CITY OF VANCOUVER

POLICY REPORT DEVELOPMENT AND BUILDING

SUBJECT: SEFC ODP and CD-1 By-law Text Amendments for 140 W 1st Avenue
(formerly 102-160 W 1st Avenue)

Figure 1: SEFC ODP Maximum Heights

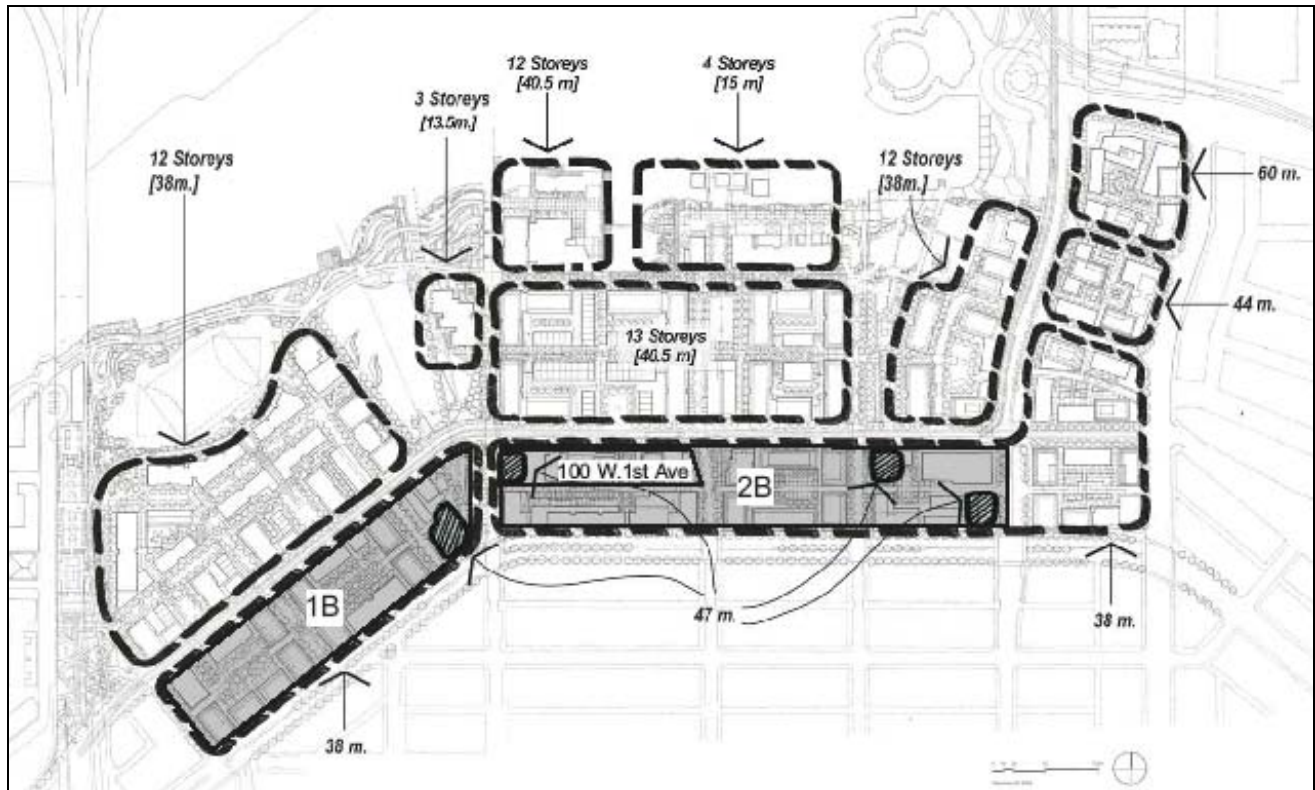
The SEFC ODP maximum allowable building height for Sub Areas 1B and 2B is generally 38 m, with a few exceptions for higher building forms at a maximum height of 47 m to define landmark locations (see: Figure 1).

Figure 2: Proposed Heights for 100 West 1st Avenue

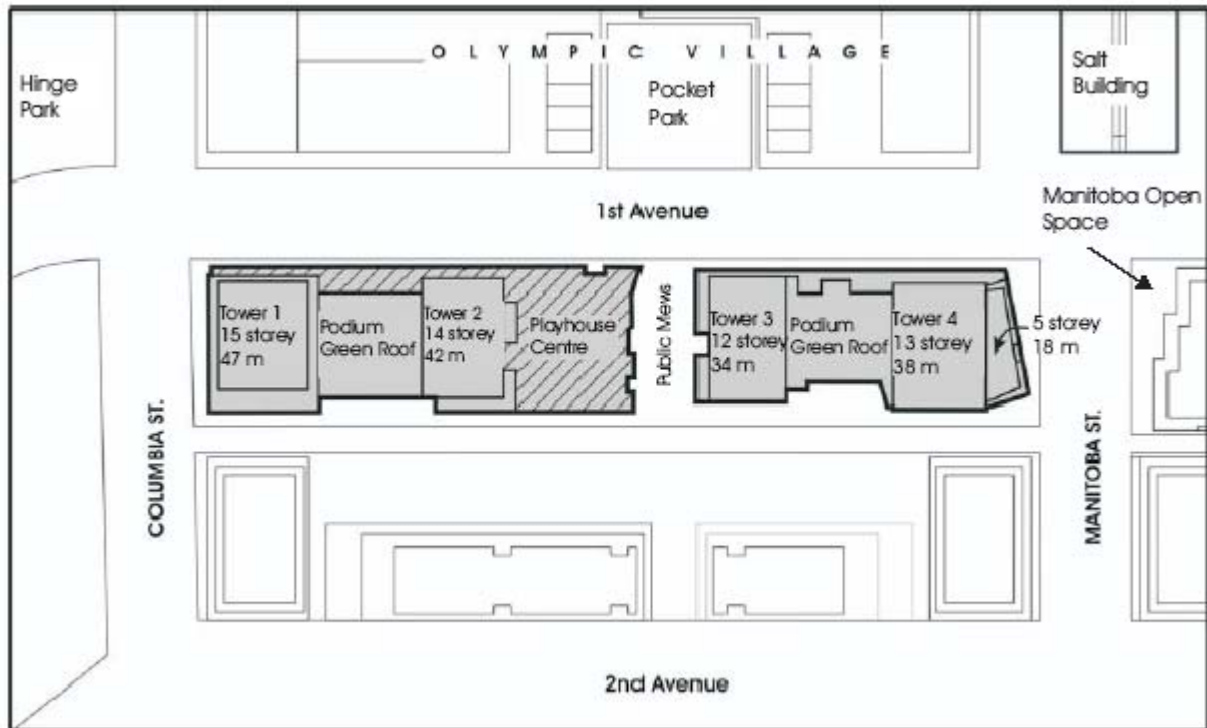
In their ODP Text Amendment application and Development Application, GBL Architects have proposed a height increase from 38 m to 42 m for Tower 2 (see Figure 2). This would result in 4 m of additional height above the current allowable ODP height. Tower 3 (see Figure 2) has also been increased by one storey (4 m) however the height falls within the 38 M height limit of the ODP, and therefore does not require an ODP text amendment.

The proposed increases in height are accompanied by reductions in height on other buildings. The height of the podium between Towers 3 and 4 has been reduced by one storey (2.6 m) and the shoulder massing of Tower 4 has been reduced by two storeys (5.6 m).

Staff have reviewed the proposed adjustments to the Form of Development and the proposed remassing reduces shadow impacts on the Manitoba Street public open space. The proposed remassing has shadow impacts along 1st Avenue and on the pocket park on the north side of 1st Avenue comparable to the Form of Development approved by Council on September 26, 2006 (see: shadowing diagram in Appendix D). This has been achieved by reducing the podium between Towers 3 and 4, by reducing the shoulder height of Tower 4 and by setting back the additional floors requested on Towers 2 and 3 such that no significant additional shadowing occurs. The revised Form of Development maintains a comparable massing while maintaining an SEFC ODP urban design objective of creating a variety of heights across the site. No additional density is being proposed; rather height increases are balanced out by height decreases elsewhere on the site (Note Plans Appendix E).

Building	Approved in principle September 2006	Proposed
Tower 2	13 storeys/38 m	14 storeys/42 m
Tower 3	11 storeys/31 m	12 storeys/34 m
Podium between Towers 3 and 4	6 storeys/17.4 m	5 storeys/14.8 m
Shoulder building beside (east of) Tower 4	7 storeys/ 20.3 m	5 storeys/14.7 m

The revised height of 42 m (building 2) meets the CD-1 By-law requirement that “no building measured above the base surface exceed 47 m.” Therefore, a CD-1 By-law Text amendment is not required to allow the increased height on Tower 2.

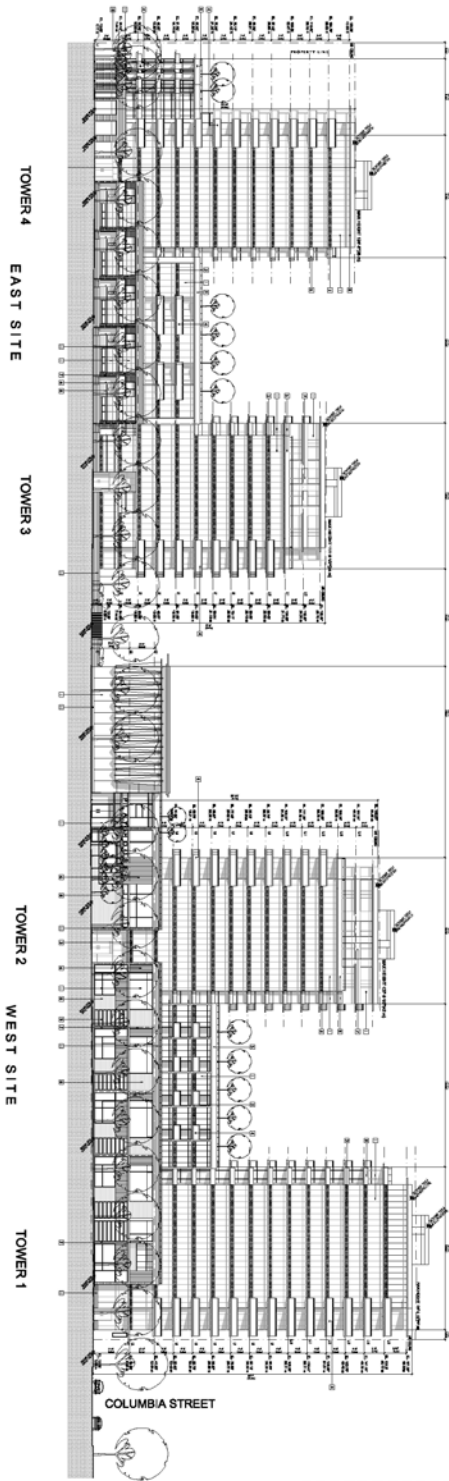
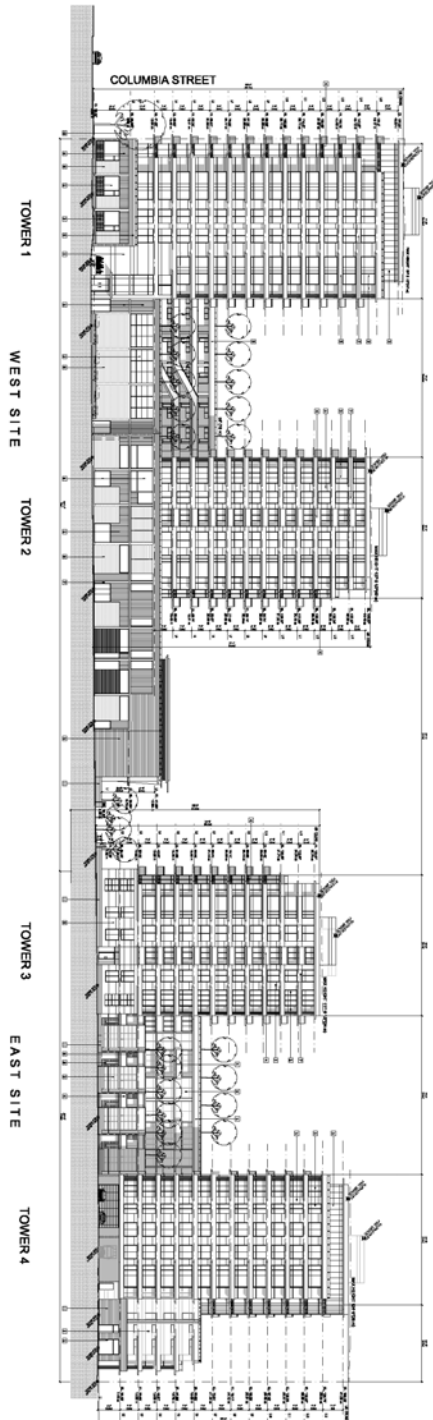
The Panel supported the adjustments to the heights of the towers with several Panel members suggesting the swoop of the tower heights could be more pronounced by adding height to the two end towers. One Panel member suggested better integrating the mechanical penthouses into the building massing. The panel had no concern about the width of the westerly tower and thought the proposed unit design would help mitigate any privacy concerns.

Several Panel members didn't think the approach to passive design was very strong and suggested increasing the solar performance of the south and west façades by further extending the proposed architectural projections or reducing the percentage of glazed openings. Also the Panel suggested increasing the size of the west facing balconies to achieve greater solar shading. One panel member recommended for this project, that the City relax the maximum 8% balcony FSR exclusion in order to achieve a greater environmental benefit.

The Panel felt the project would fit well into SEFC although one member thought it wasn't as successful as other projects in the area. Generally, the panel thought the expression of the four towers was too uniform and monotonous, and could be more distinctive. One panel member suggested using more depth and layers in the facade treatment to create a stronger architectural expression. The panel thought the two storey base expression was more successful than the towers above. One panel member thought the retail expression on Manitoba Street could be stronger, with the project's typical two story base expression continuing along Manitoba Street.
